# 1 Purpose of Document

This document summarizes the changes between the previous ASI4U silicon revision C and the current silicon revision E. These include requested UART design changes. The purpose of the redesign was to correct reported timing errors by the UART in the following modes: Master, Monitor, and Repeater. A problem with slave communication in special network constellations was also fixed.

**Figure 2.1 Comparison of Valid MAN-Code Signal to Faulty MAN-Code Signal**

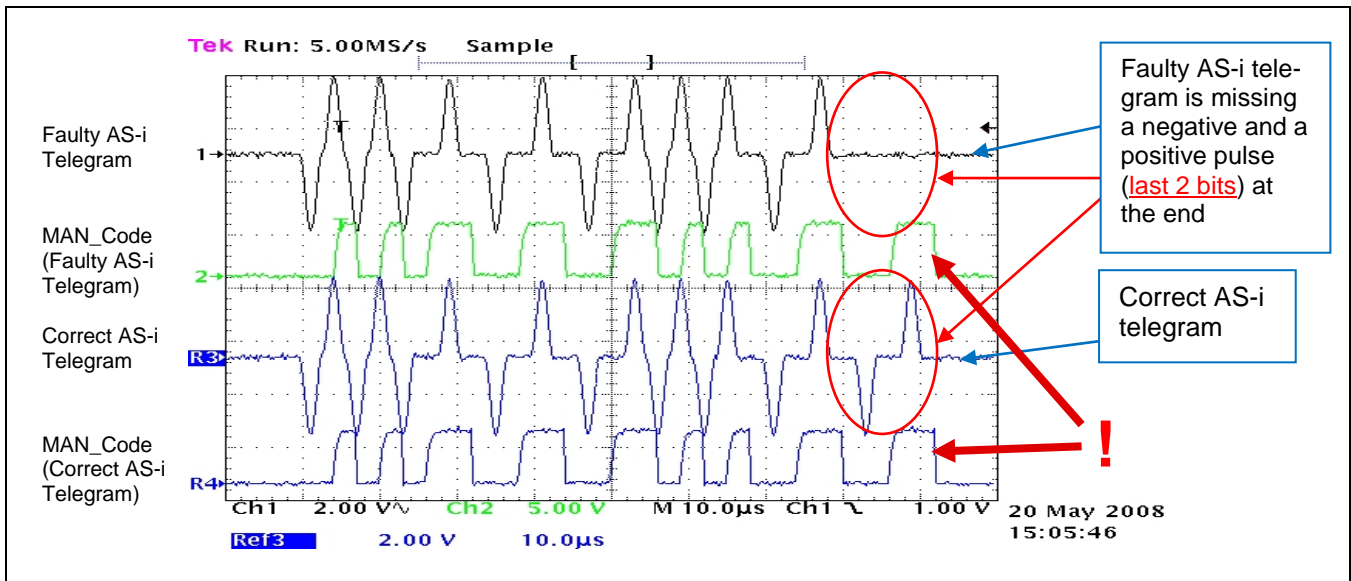
If the ASI4U revision C operates in Master Mode, Monitor Mode or Repeater Mode, the error signaling for an *End\_Bit\_Error* does not work correctly. In some special cases, the generated MAN-Code of a signal with an *End\_Bit\_Error* looks similar to the MAN-Code of a signal without any errors as demonstrated in Figure 2.1.

This malfunction of the ASI4U revision C results in an MAN-coded output signal that does not allow distinction between correct AS-I pulse sequences and pulse sequences that are shortened (missing one negative and one positive pulse). It occurs only under the following conditions:

- The parity of the signal is even.
- The last bit of the corrupt telegram is equal to binary 1.
- The *Stop\_Bit* and the *Parity\_Bit* or the *Start\_Bit* and the *Control\_Bit* are missing.
- If the *Start\_Bit* and the *Control\_Bit* are missing, the first pulse must have a negative polarity.

1. The last pulse of the MAN-coded LED1 output signal is now always kept in ACTIVE state for 9 $\mu$ s if an ASI telegram with an *Endbit\_error* is received.

The polarity of the ACTIVE State depends on the signal setting at the DI ports in Master Mode, Monitor Mode, and Repeater Mode. If DI2 and DI3 are driven by equal input signals, the MAN output signal at LED1 is configured ACTIVE LOW. If DI2 and DI3 are driven by unequal input signals, LED1 becomes inverted and is configured ACTIVE HIGH.

Since a 9 $\mu$ s-wide MAN pulse is an out-of-specification event for the AS-I MAN signal, it will allow the connected microcontroller to recognize the error in the AS-I pulse signal on the AS-I line.

**Figure 3.1 Test for ASI4U Revision C Error in Master Pause Detection**

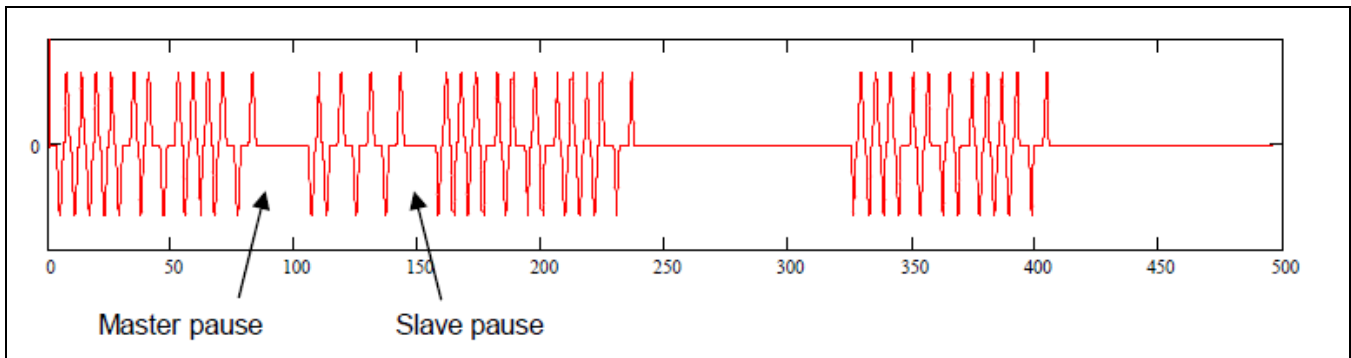
If the previous ASI4U revision C is operated in Slave Mode, the UART Master Pause detection does not always function correctly when the UART must listen to slave responses from a different slave. Depending on the actual AS-I line pulse timing, a slave response from a different slave is sometimes not recognized correctly, which results in a UART communication error. This prevents the Slave from understanding the next Master telegram correctly. If the Master telegram addresses the Slave itself, the error leads to a missing slave response and the Slave replies on a second repetition of the Master Call to its own address in asynchronous mode.

Figure 3.1 shows a telegram test case to reproduce the error. The AS-I signals shown in Figure 3.1 were generated by a signal generator that allowed sweeping the Master Pause and Slave Pause duration over the allowed specification limit. The first Master Call contains a different slave address than the tested slave. The second and third master calls address the tested slave. The tested slave replied with the erroneous behavior for certain Master pause and Slave pause scenarios only. The majority of the test cases were passed without error.

A new principle of AS-i telegram pause detection was implemented in ASI4U silicon revision E that is more precise and able to cover all valid timing scenarios for Master and Slave pauses. The new principle is now independent of the internal timing constraints of the UART state machine.
